ECE/TRANS/WP.29/GRE/2009/19  
16 January 2009

COLLECTIVE AMENDMENTS

Regulations Nos. 6 and 7

Proposal for draft Supplements to Regulations No. 6 and 7

Annex 2.

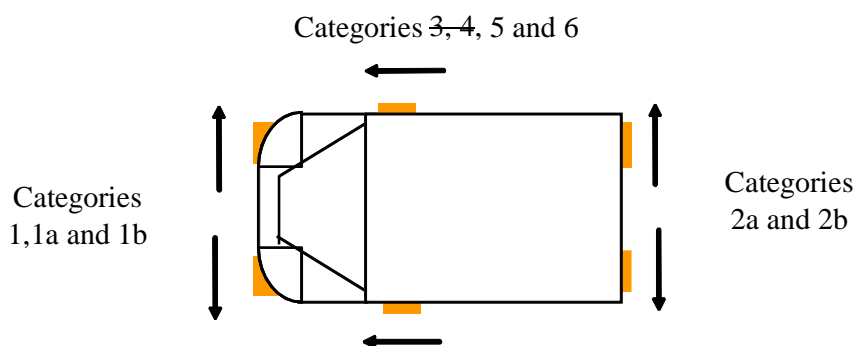
Item 9, amend to read:

"9. Concise description:  
....  
Category: 1, 1a, 1b, 2a, 2b, ~~3, 4~~, 5, 6 2/  
...."
